***INSPECTION REPORT***

REPORT COMPRISING OBSERVATIONS AND FINDINGS IN RELATION TO EXTERNAL ASPECTS OF:

**PLOT 25 – [REDACTED]**

**Figure 1.1 – Supplied drawing showing Plot 25**

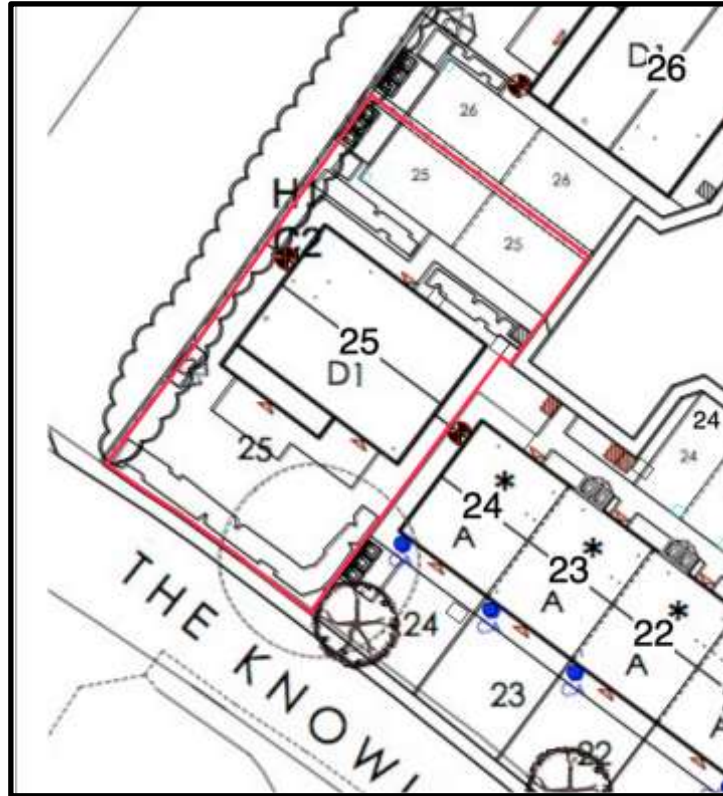
When comparison between the drawing provided and what the developer has produced is made, many significant differences can be seen. These are notably:

- The presence of a 'bin store' at the end of the driveway in the drawing - ***this has not been provided to Plot 25***
- The access to Plot 25 coming from the road – ***access to Plot 25 has not been constructed in this way***
- The absence of a retaining wall in the rear garden – ***Plot 25 has a retaining wall in the rear garden returning down the side of the house***
- The absence of a retaining wall at the end of the driveway – ***Plot 25 has a retaining wall at the end of the driveway***
- The presence of a garden at the rear separate to the patio area – ***this has not been provided to Plot 25***

**Figure 2.2: Drawing provided to homeowner - Annotated**

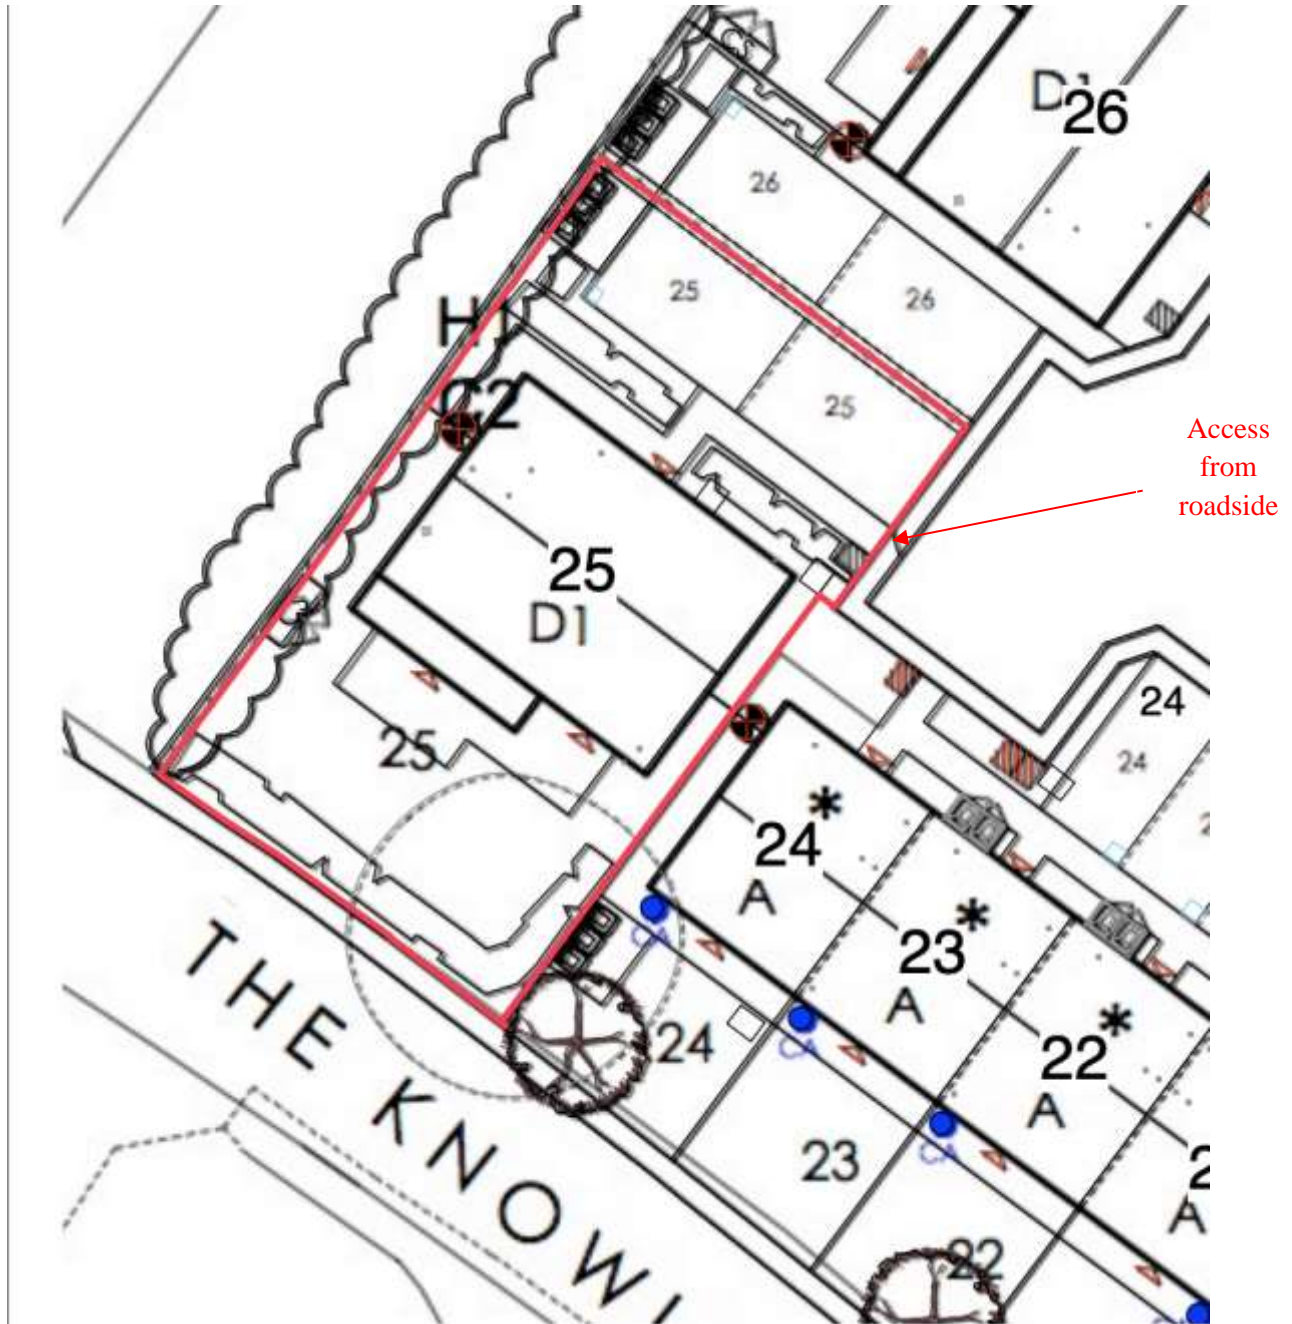
The drawing provided to the homeowners during the purchase of the property, **Figure 2.2**, depicts the access route coming from the road, mitigating the need for the additional 900mm walkway. In reality, the access has been constructed from the far side of the driveway, **Figure 2.3**, therefore the driveway forms part of the access route. Had the access been constructed as shown in drawing provided to the homeowners, this issue would not have arisen. It is not clear why the deviation from the drawing provided to the homeowners has occurred.

**Figure 4.6** Representative image showing insufficient weep-holes

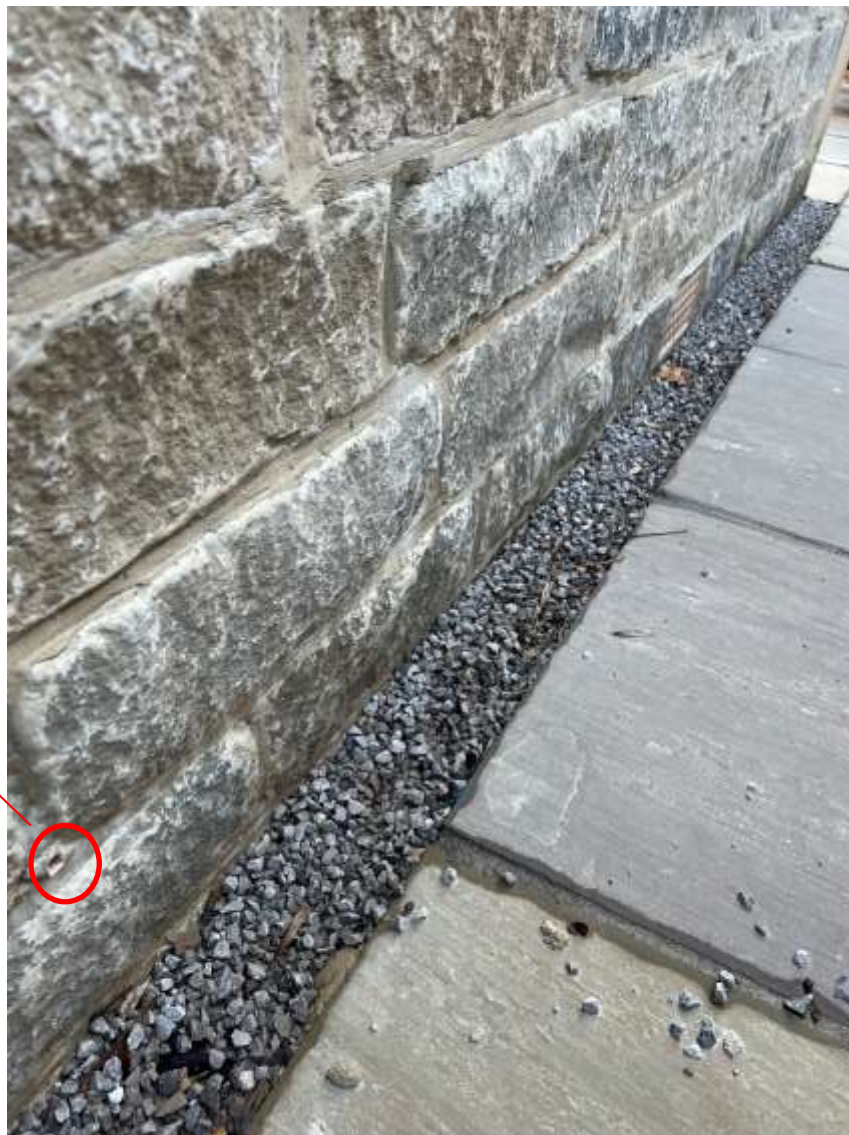
At several locations on plot 25 inadequate weep-holes have been used in construction, particularly at the DPC course close to ground level, where they have been missed or placed further apart than the 900mm limit. Representative image, **Figure 4.6**.

Last weep-vent on  
that stretch of  
stonework

**Figure 5.2** Representative images showing lack of Edgings used

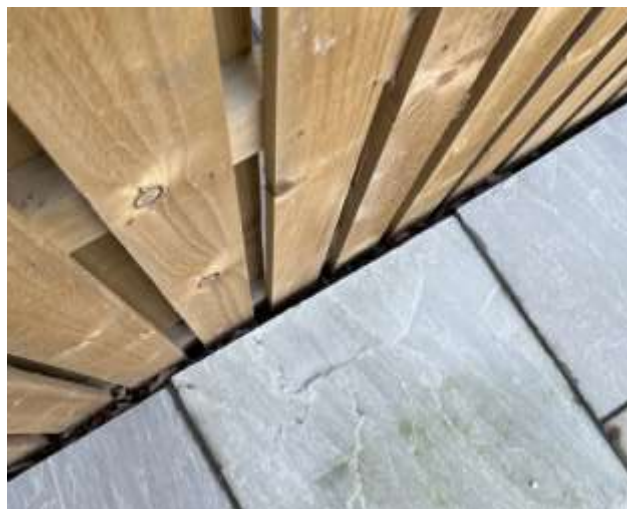
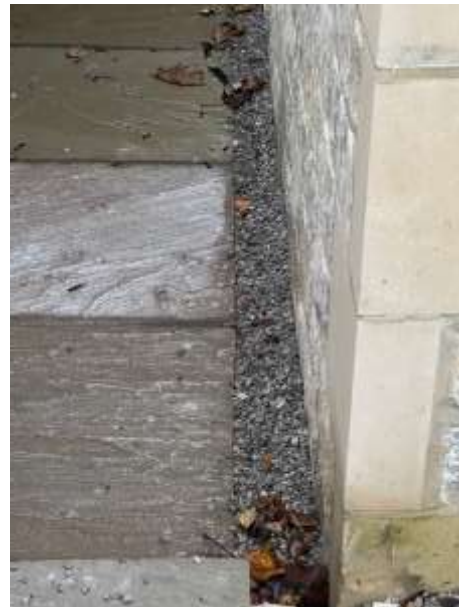
No edgings have been used on the entirety of the paths on Plot 25, representative images, **Figure 5.2**.

**Figure 5.4** Representative images showing differences in mortar colour and poor pointing

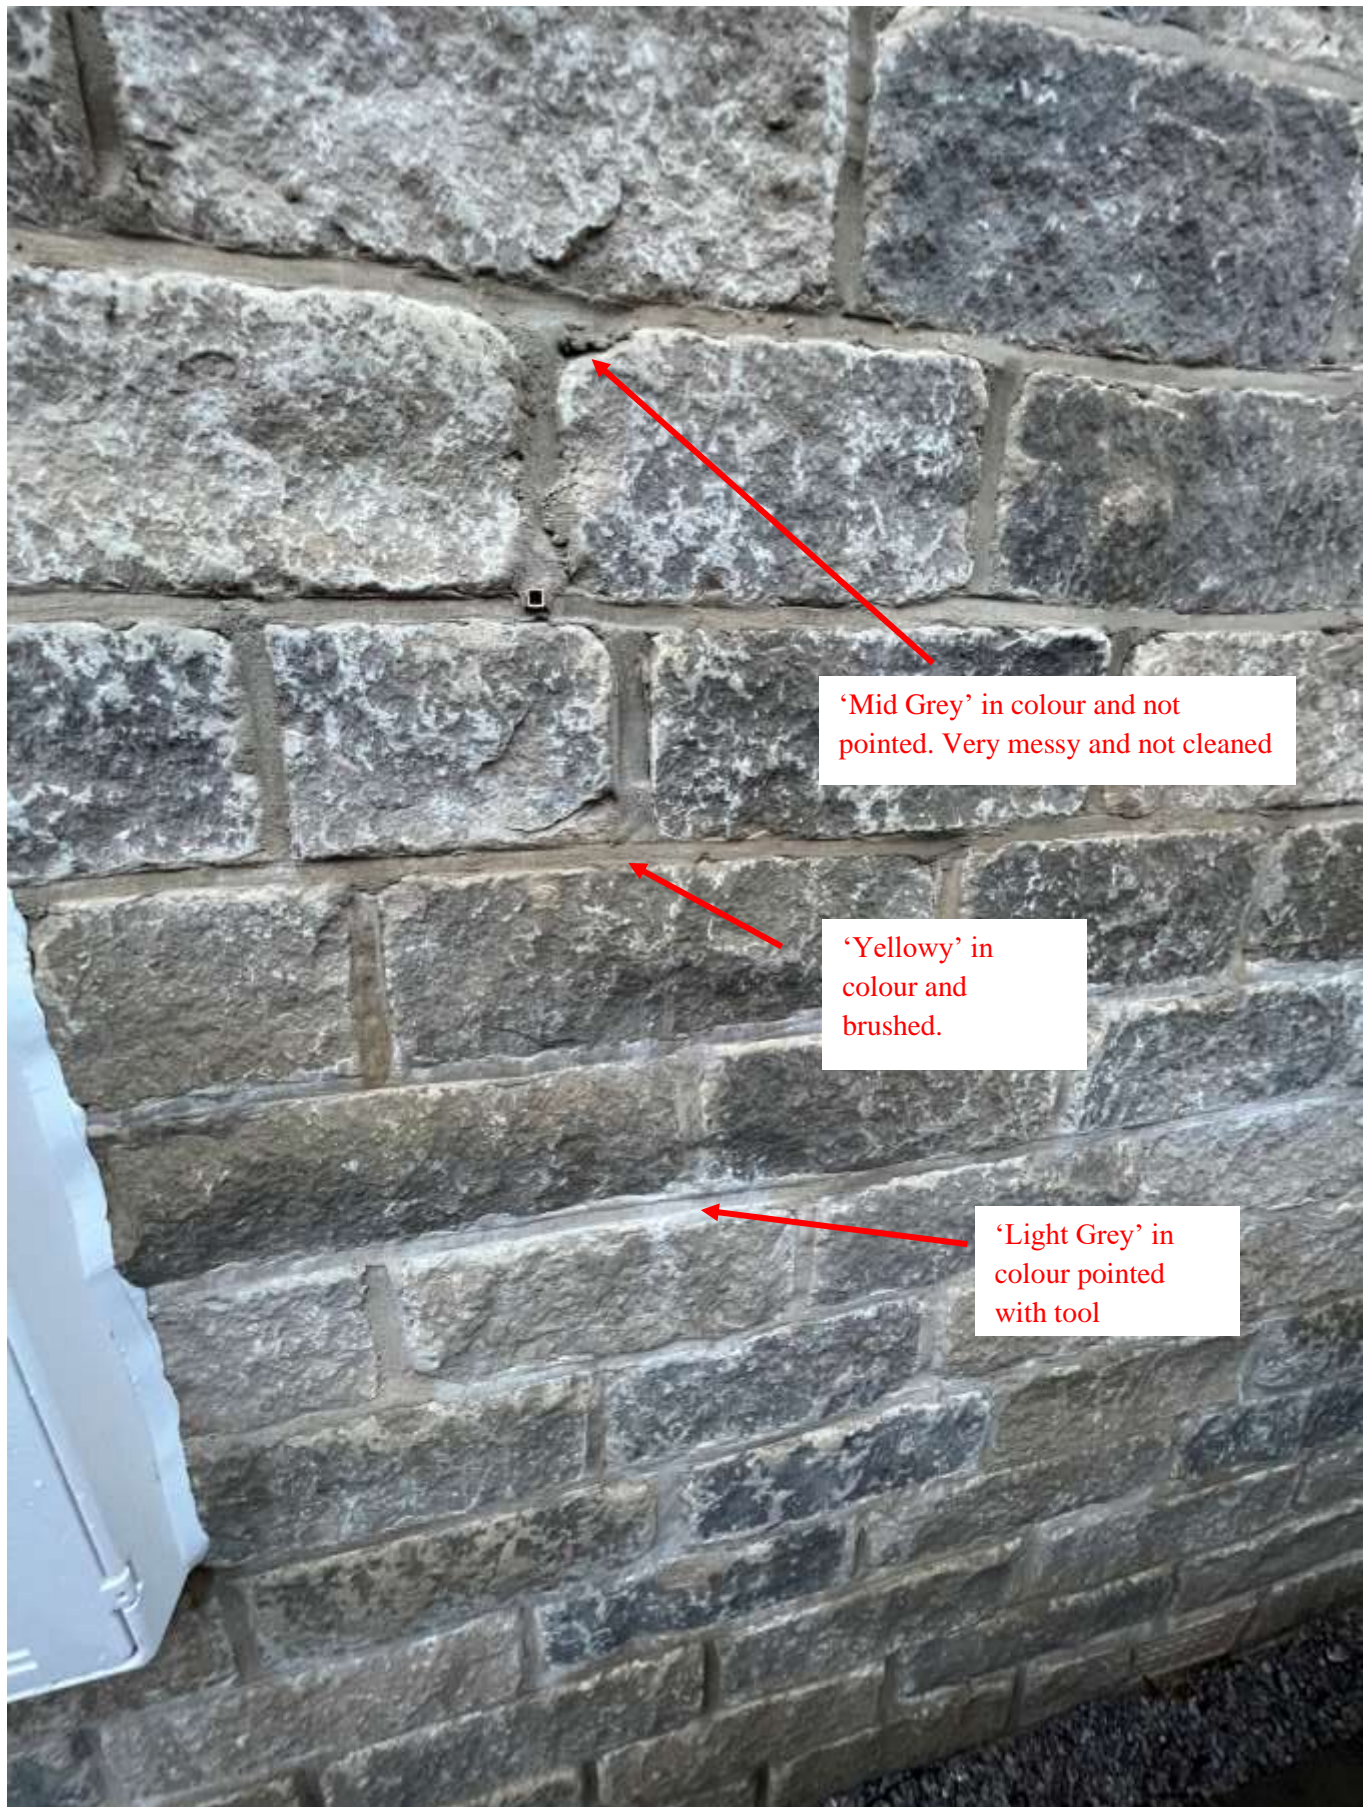
The quality of the mortar and pointing is extremely inconsistent across the entirety of Plot 25. Differences in mortar colour and pointing quality are shown in a representative image, **Figure 5.4**.

**Figure 5.6 Representative images showing mis-aligned quoins**

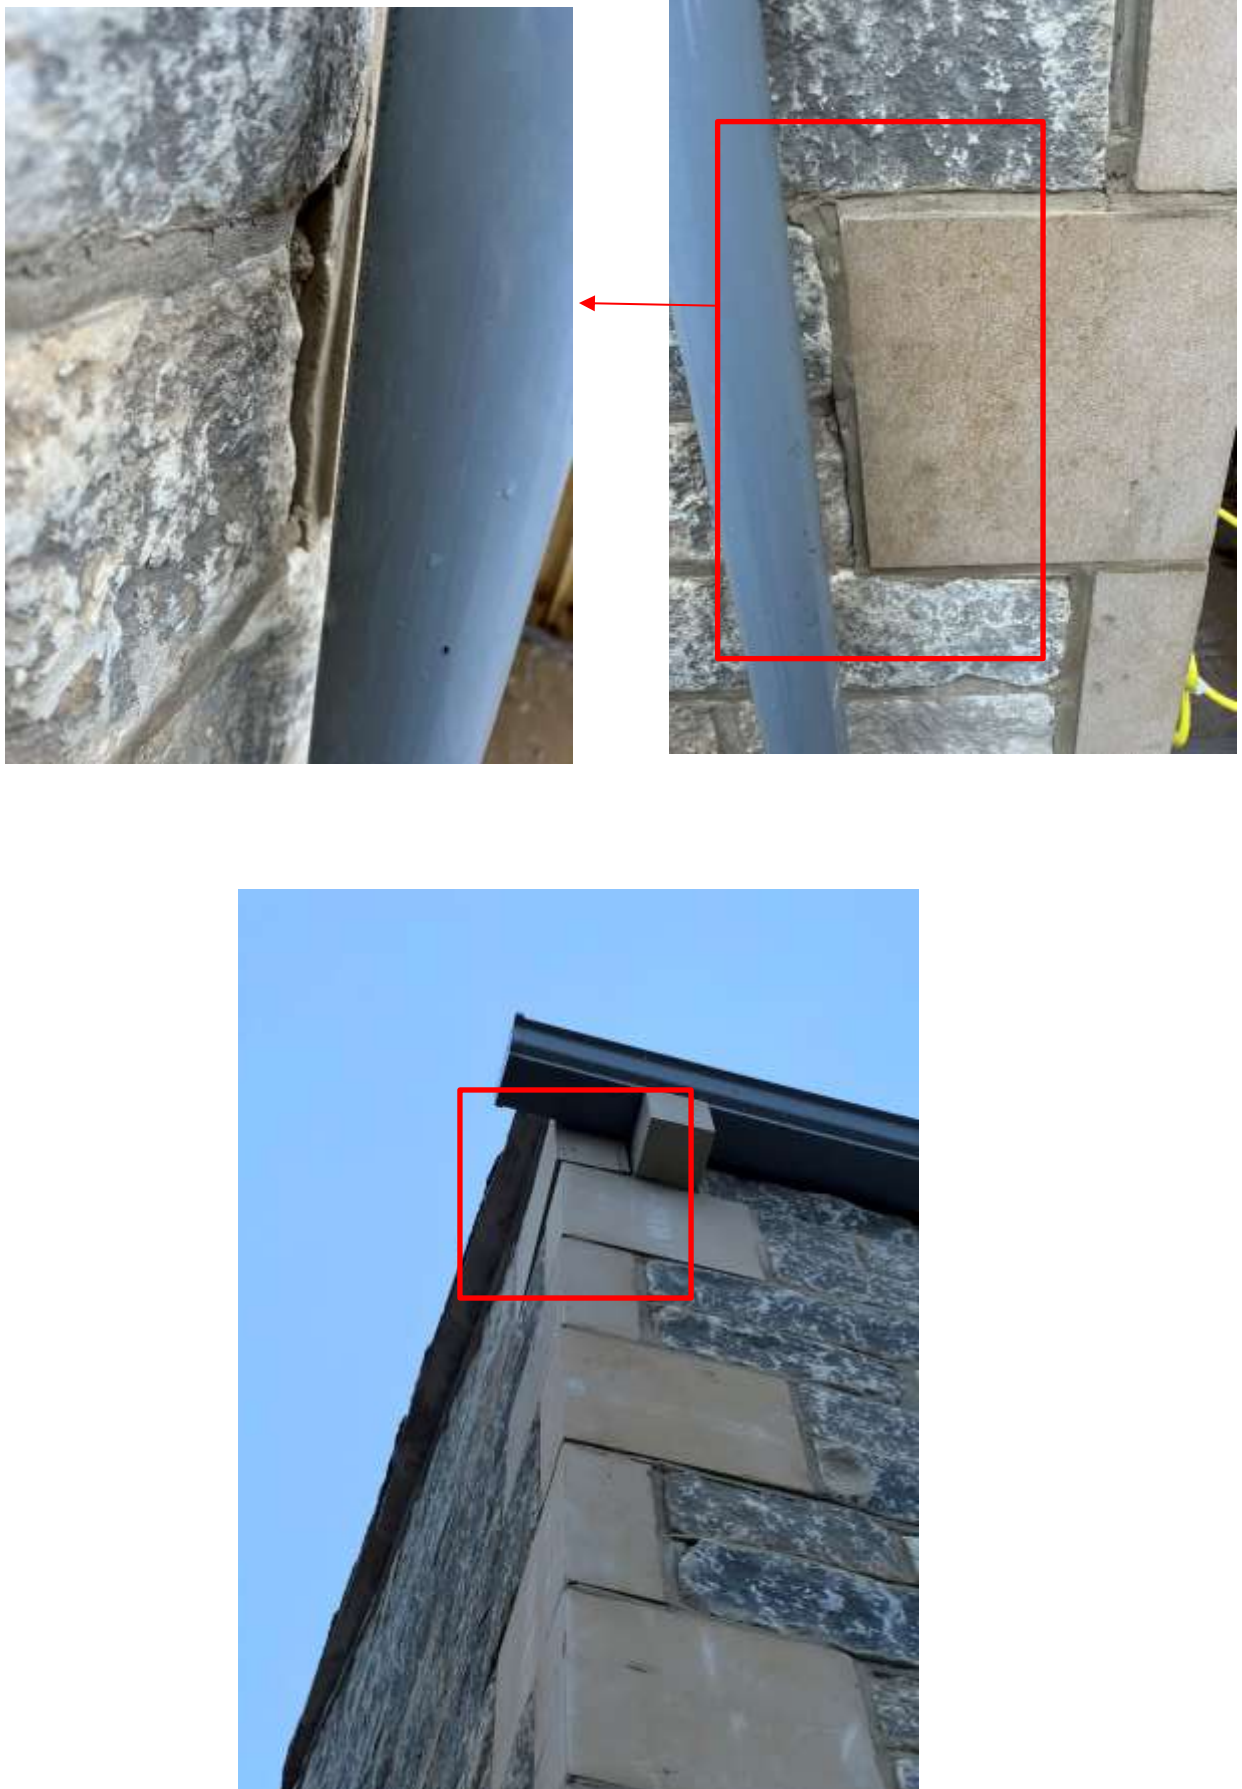
The alignment of the quoin stones in relation to the adjacent stonework is also poor in some locations, with some quoin's mis-aligned or coming away from the stonework. Representative images, **Figure 5.6**.

**Figure 5.8 Unnecessary retaining wall wasting space**

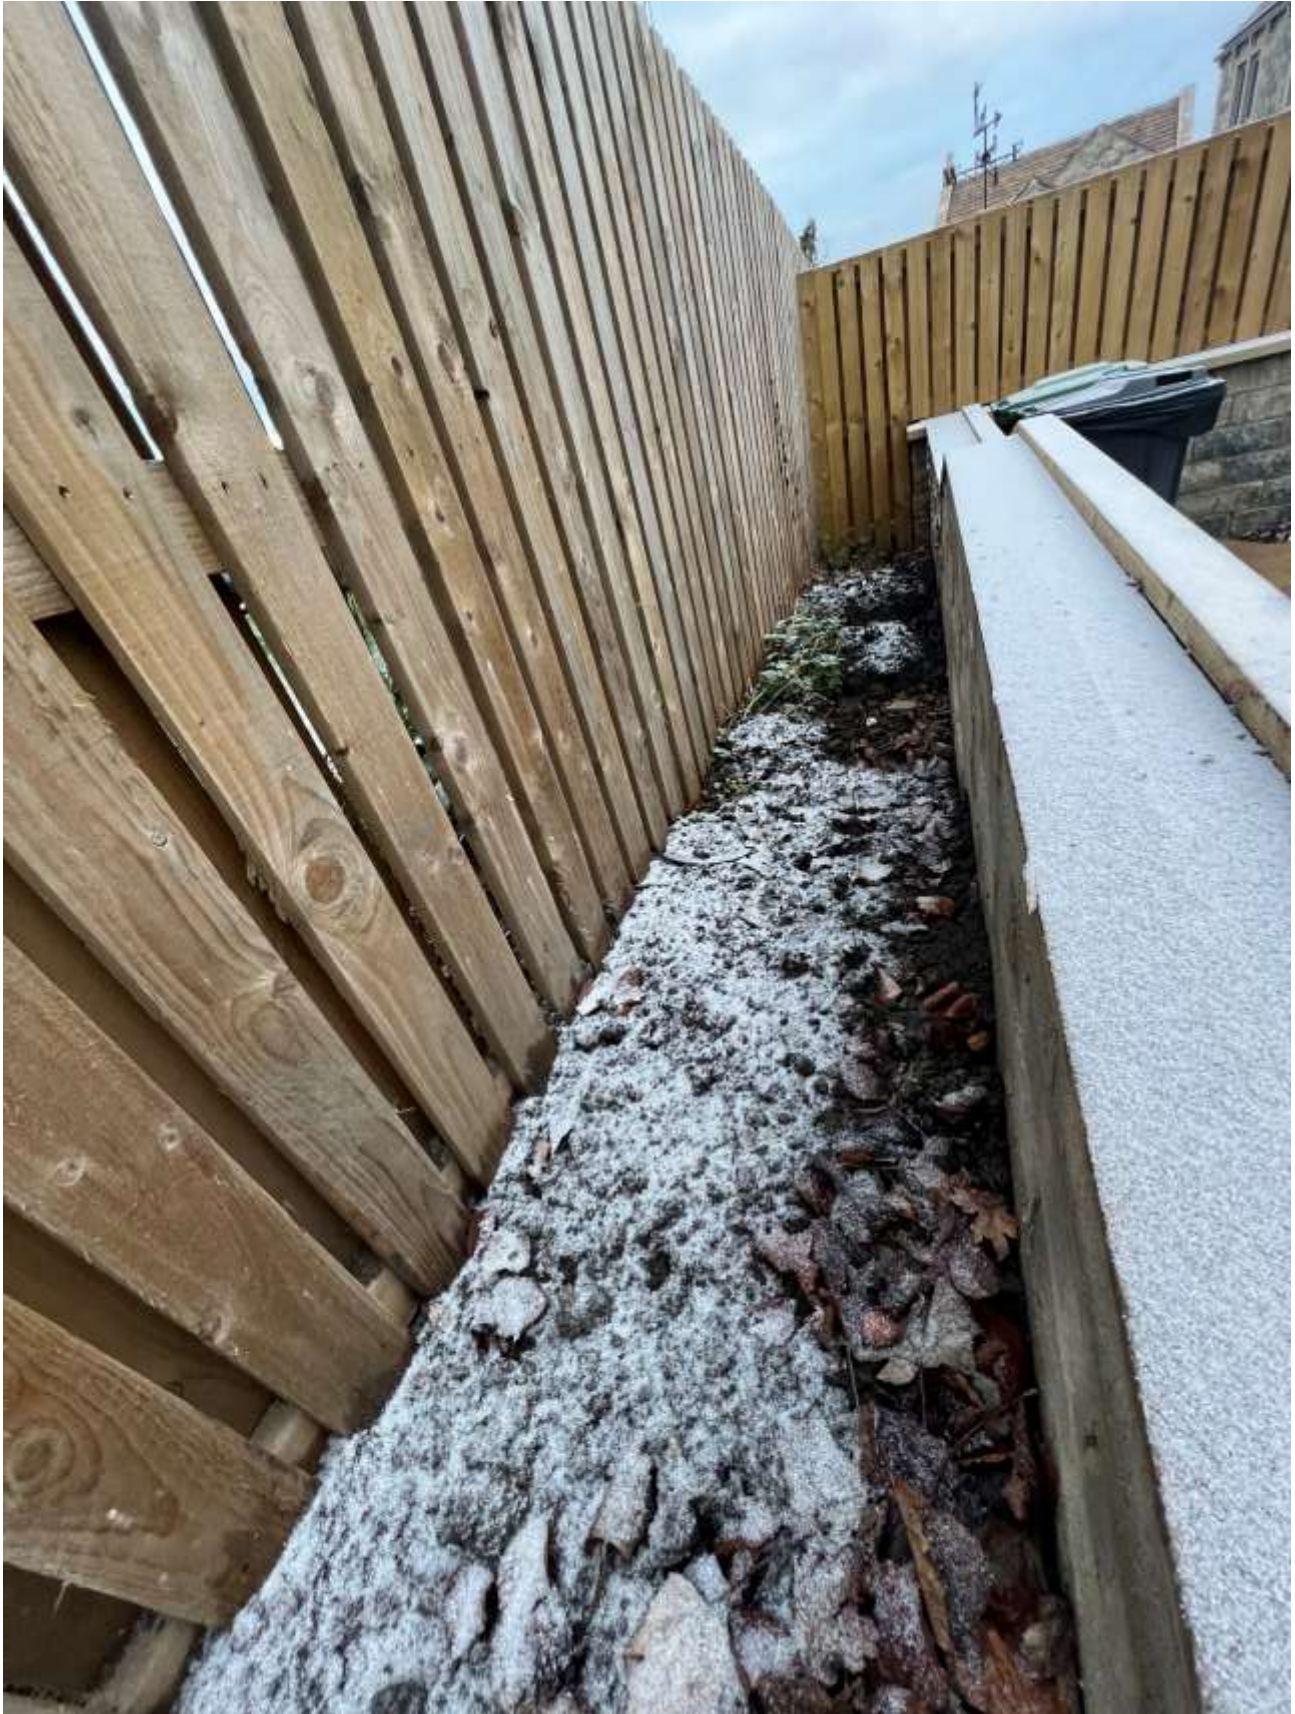
The retaining wall built at the end of the driveway appears to be unnecessary, as it is not retaining any earth and in the opinion of the homeowners, will act as a 'rubbish trap'. There is no provided access to maintain this area safely. The retaining wall was not detailed in any plan provided and has actually impeded the space that was designated for bin stores, **Figure 5.8**.
